Status Report of New Issues TF –CFD* sub wg

*CFD: Computational Fluid Dynamics method, method to simulate aero drag

24th Sept., 2019

- 1) **Certification scope single baseline:** using multiple parts (a, b, c) with mixed number of modifications per part vs. one baseline 5/5

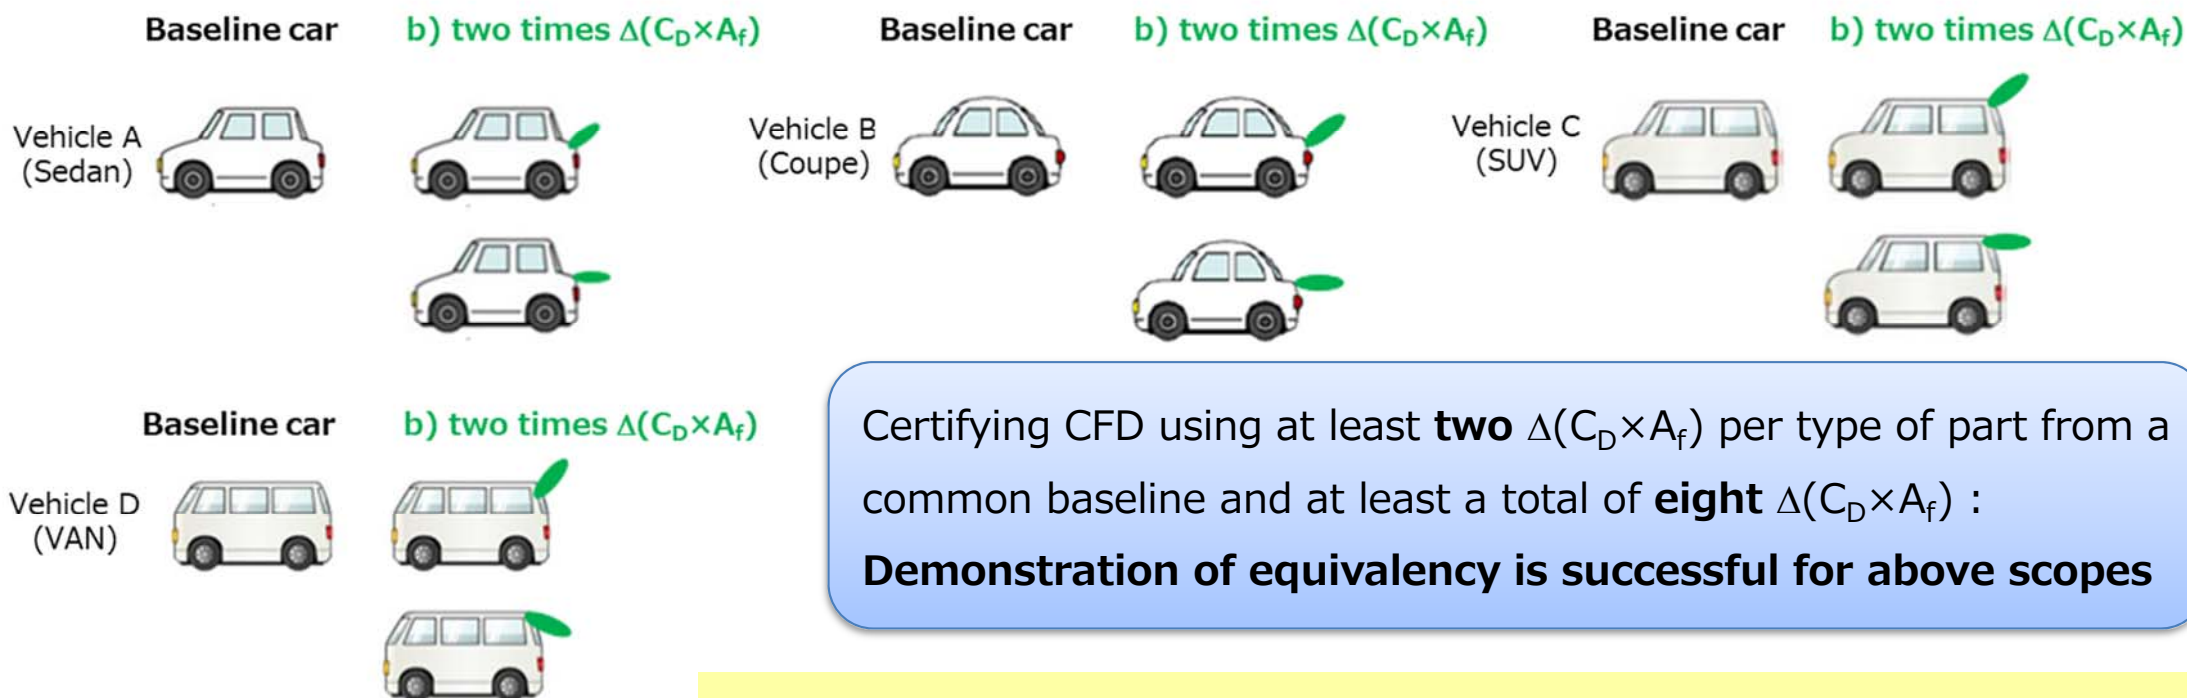
- 2) **Certification scope multiple baselines:** using single type of part (b) applied on different baseline vehicles

Certifying CFD using at least **two** $\Delta(C_D \times A_f)$ per type of part from a common baseline and at least a total of **eight** $\Delta(C_D \times A_f)$:

Demonstration of equivalency is successful for above scopes
